RESPONSE TO REQUEST FOR ADDITIONAL INFORMATION

NUREG-0737, ITEM II.K.3.28

QUALIFICATION OF ADS ACCUMULATOR SYSTEMS

VERMONT YANKEE NUCLEAR POWER STATION

ATTACHMENT #1

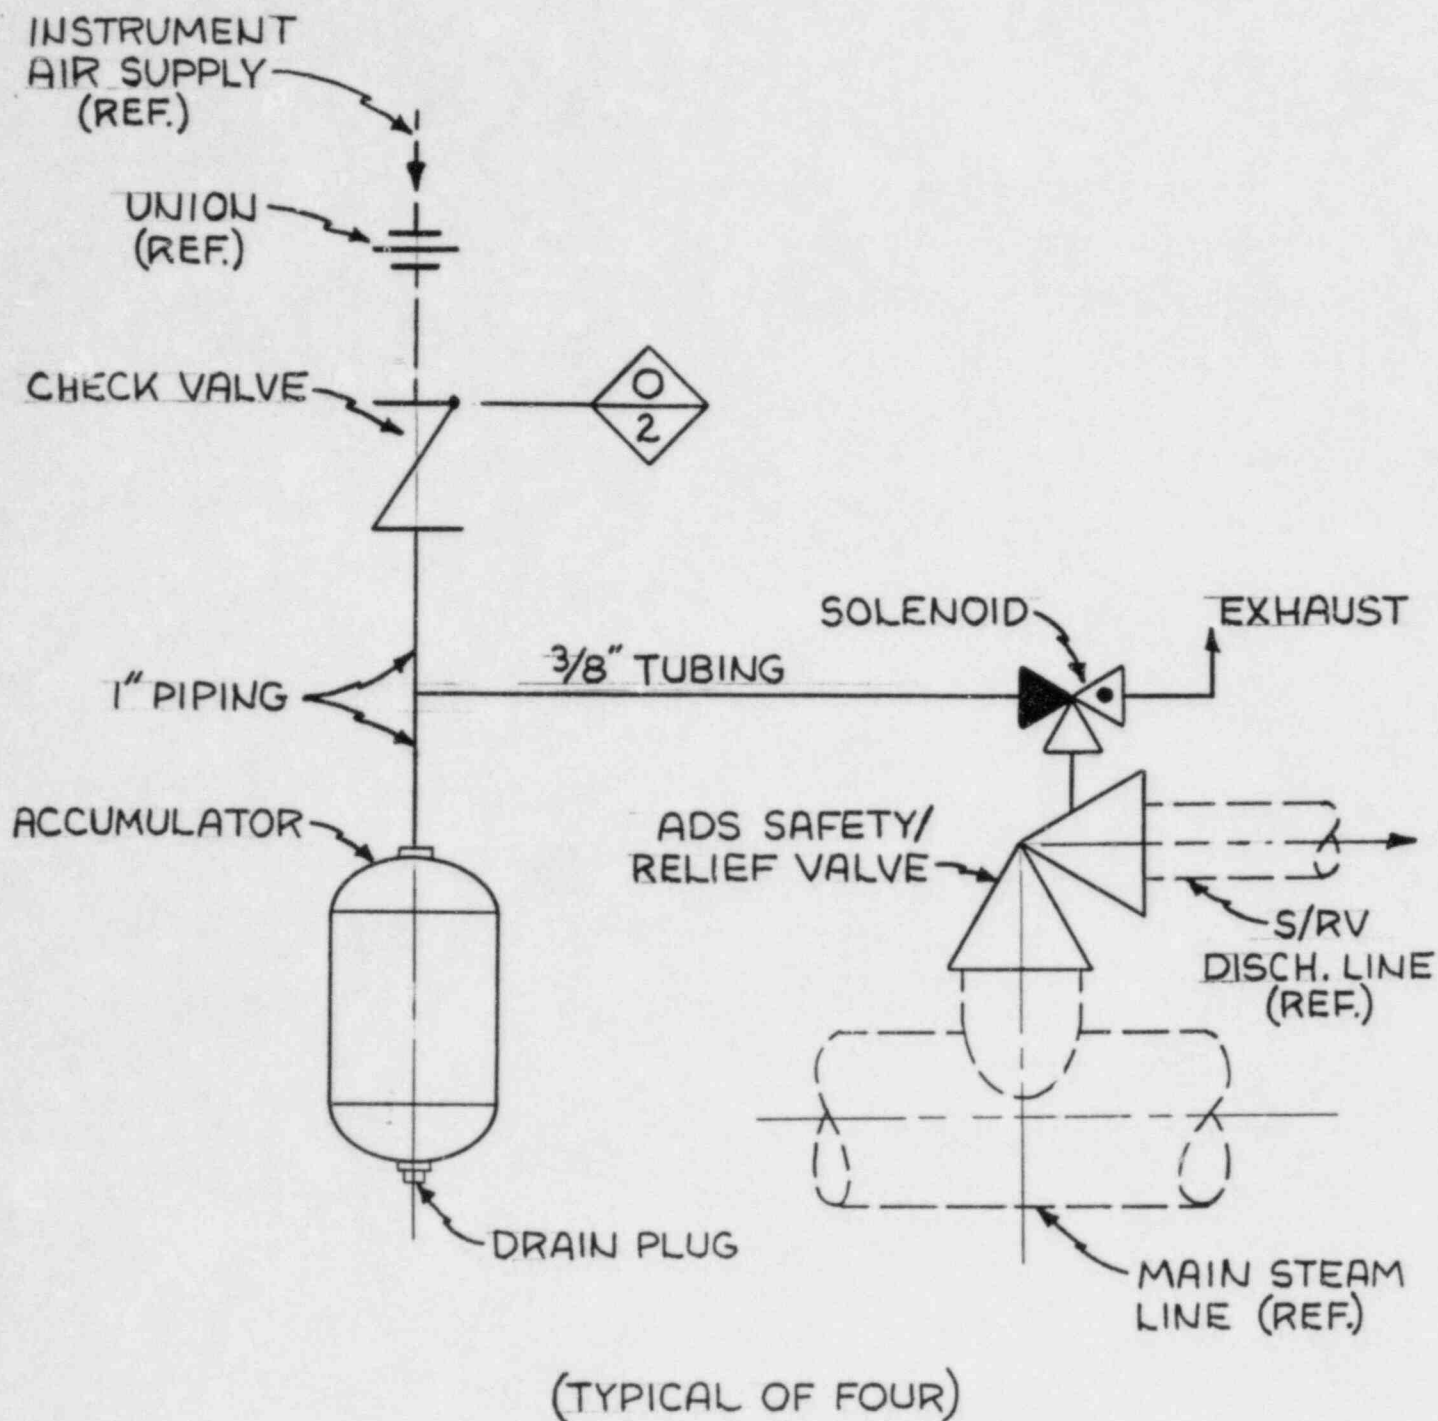
Describe the ADS Accumulator System design and operation (e.g., trains, air supply, capacity, alarms, instrumentation, and their location, etc.).

The function of the ADS Accumulator System is to provide a reserve of compressed nitrogen (or air) for operation of the ADS System Safety/Relief Valves, in case of a failure (including line break) of the drywell instrument air supply.

An individual ADS accumulator is associated with each ADS Safety/Relief Valve (4 total). Each accumulator has 0.189 ft³ (1.414 gal) capacity. The accumulators are connected to the drywell instrument air supply by one-inch carbon steel piping. Each ADS S/RV solenoid is connected to the one-inch supply line by 3/8 inch stainless steel flexible tubing.

A "NUPRO" stainless steel, soft-seated check valve is installed in the instrument air supply line to each accumulator and solenoid. The purpose of this check valve is to keep the ADS Accumulator System pressurized by sealing off the instrument air supply line, in case of a loss of drywell instrument air supply pressure. As a result of I&E Bulletin 80-01, the original "Hancock" hard-seated check valves were replaced with the present "NUPRO" check valves to insure ADS accumulator leak-tightness.

All piping and components from the "NUPRO" check valves to both the ADS accumulators and the S/RV solenoids (inclusive of these components) is classified as Nuclear Safety Class 2 and Seismic Category I. This defines the boundaries of the ADS Accumulator System.

All equipment is located in the drywell. There are no alarms or instrumentation directly associated with the system; however, a high-low pressure alarm exists on the non-safety class instrument air supply line to the drywell.

See the attached sketch (Attachment 1) for a diagram of the ADS Accumulator System.
